SB 186-18

RCV Hot Weather Precautions

Fig. 1

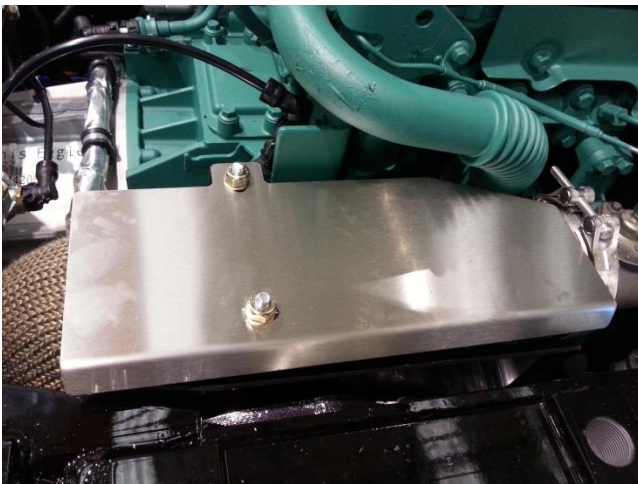
- It is recommended these areas are inspected daily and addressed accordingly. Adding this element to drivers daily checks would be a good measure.
- It is important that all exhaust guards/socks are fitted to the exhaust without any visible damage.
- Exhaust joints and flexi pipes must be free from any leaks.
- Exhaust/Turbo guard should be fitted as per Fig. 1 below. This was raised as a campaign by DE back in March 2016 ref CP202 under Service Bulletin SB155-16. If you do not have this guard fitted please contact Dennis Eagle parts quoting SL1132 as a part number, the guard will be supplied FOC for you to fit at the earliest time possible.
